# MIT/IL SOFTWARE ANOMALY REPORT

PS 1085  
 MSC REPORT NO. 1-1B-10  
 PROGRAM LUMINARY 1B  
 PROGRAM REVISION 116

Fig. 3.4-16. Manual rate control logic for the P axis.

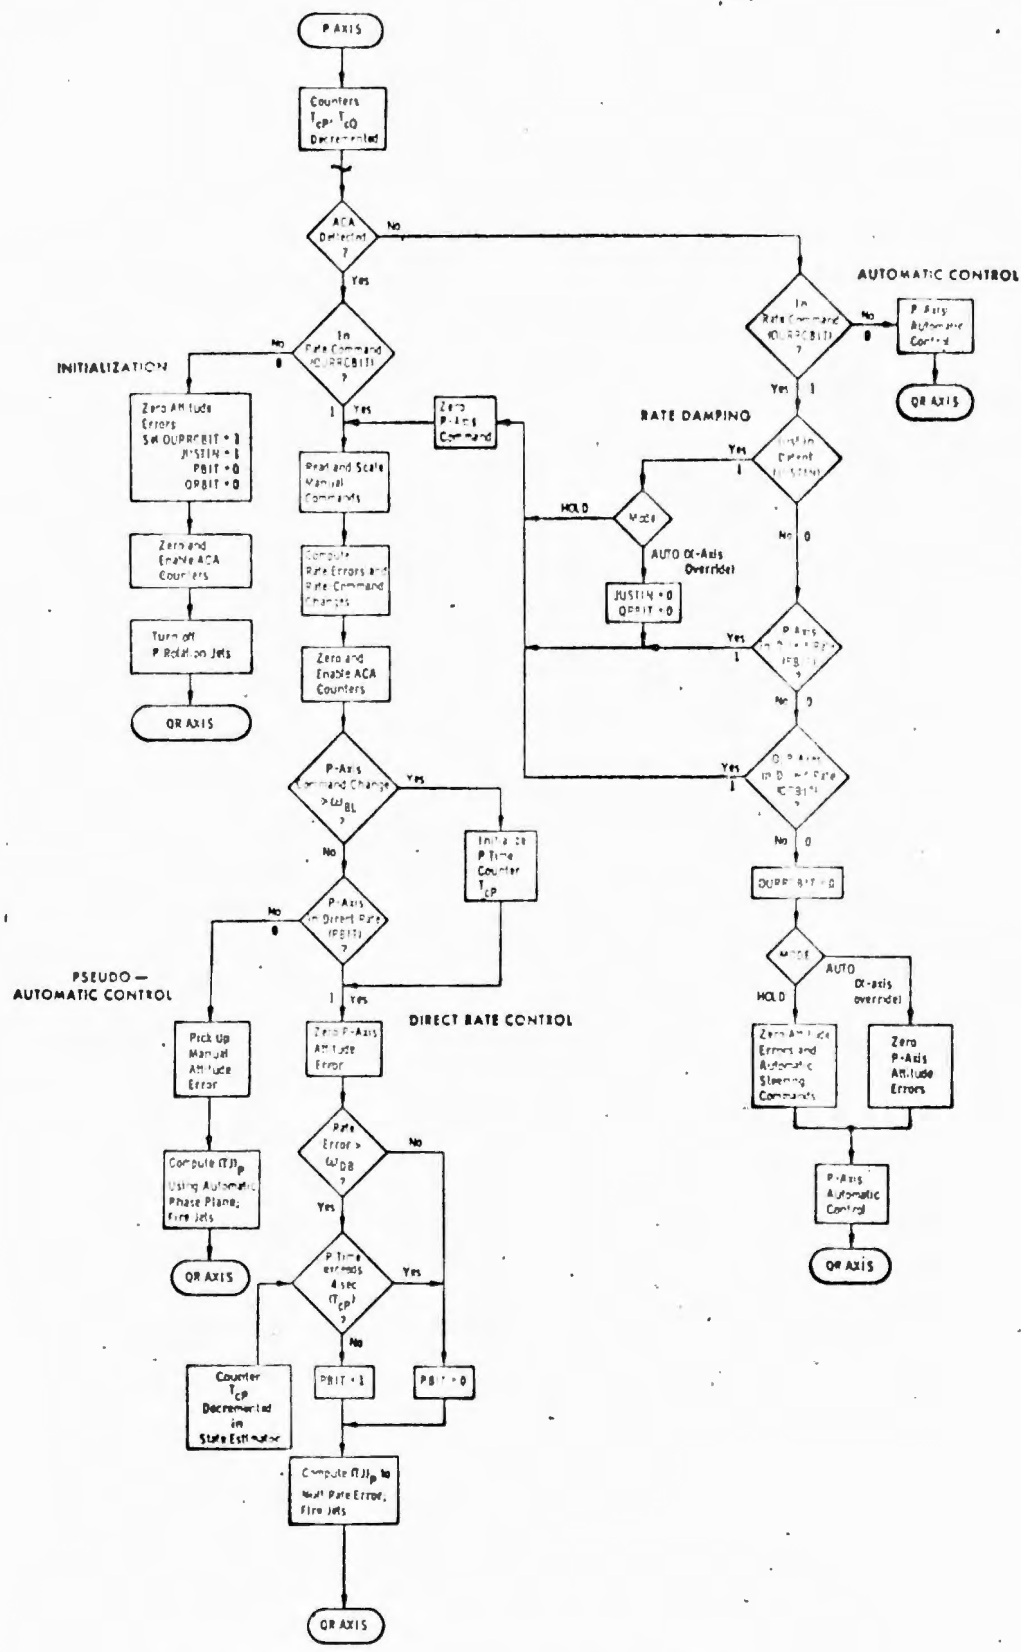
When the ACA is returned to the detent position after being recycled in and out of detent in the manual rate command mode, the DAP may enter the attitude hold mode immediately, rather than first damping the spacecraft rates as desired.

" The effect is related to the handling of RCSFLAGS B09, JUSTIN. What happens can be seen by following the history of RCSFLAGS and DAPBOOLS B12, OURRCFLG, thru the above sequence, with the aid of Figure 3.4-16 and -17 of Section 3 of the GSOP (attached). When the stick is just moved out of detent OURRCFLG is tested and since it is 0 an initialization pass is made in P-Axis. It is at this point that OURRCFLG and JUSTIN are set (made equal 1).

When the stick is returned to detent as detected in P axis (Fig. 3.4-16), OURRCFLG is tested and since it is 1, JUSTIN is tested. Since JUSTIN is also 1, the routine would continue on to Q, R -Axis (Fig. 3.4-17). Here the condition of the stick (as determined by a check of CH31 in P-Axis and buffered in CH31TEMP) is checked.

Since it is in detent OURRCFLG is checked and being found set, JUSTIN is reset. Assuming rate command changes and prime axes rate errors greater than the break out level and the rate deadbands respectively, Direct Rate Control will be established by setting RCSFLAGS B11, QRBIT. On the next P-Axis pass with the stick still in detent OURRCFLG is still set but though JUSTIN is reset, transfer is made to Q, R - Axes without resetting OURRCFLG (see Fig. 3.4-16) because QRBIT is set.

However, if the stick is returned to detent after Pseudo - Auto has been established (QRBIT reset) then after the test of OURRCFLG (refer to Fig. 3.4-16) the tests on JUSTIN and QRBIT will find them both reset so OURRCFLG will be reset. Now in Q, R - axes, when OURRCFLG is tested and found to be reset, the program flow will be transferred to Automatic Control.

Set JUSTIN to 1 each time the ACA is found out of detent in Fig. 3.4-16.

No action required for LUMINARY 1B.  
Fix coding for LUMINARY 1C.
